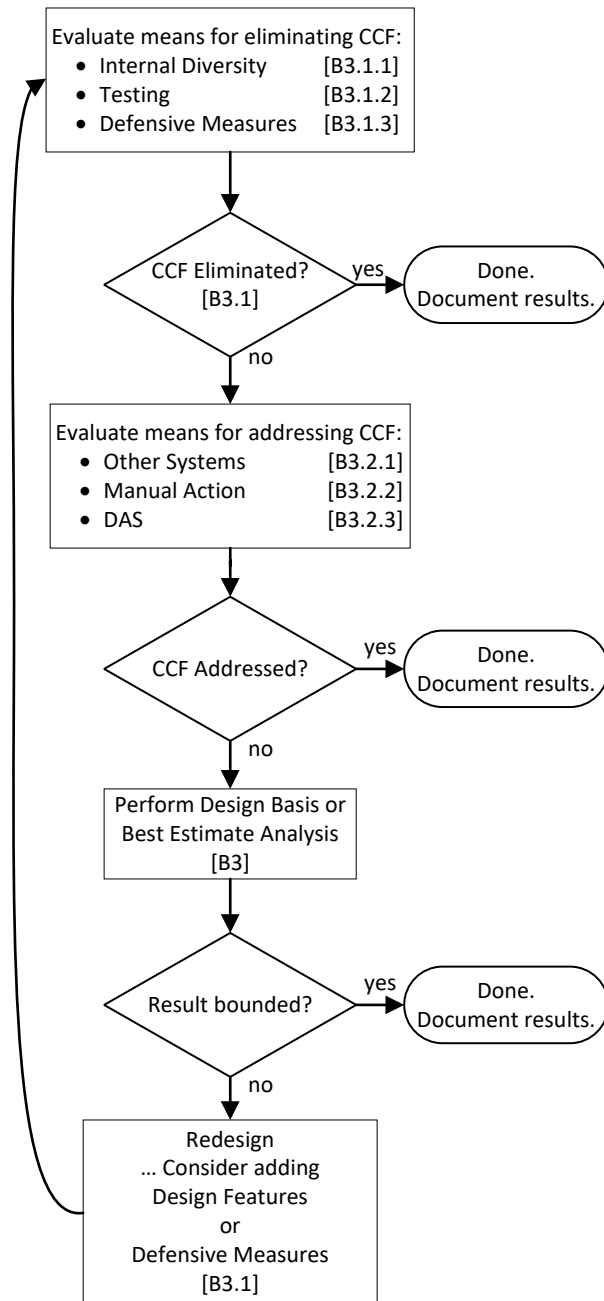
The Graphic itself should not include a title – the title should be presented in a Word Caption block to facilitate program automation and formatting functions.

A recommended title would be something like this:

A Process for Evaluating Potential Loss of Function due to CCF that Could Result from the Use of Digital Technology.

This is intended to tie the figure to the scope of the BTP.
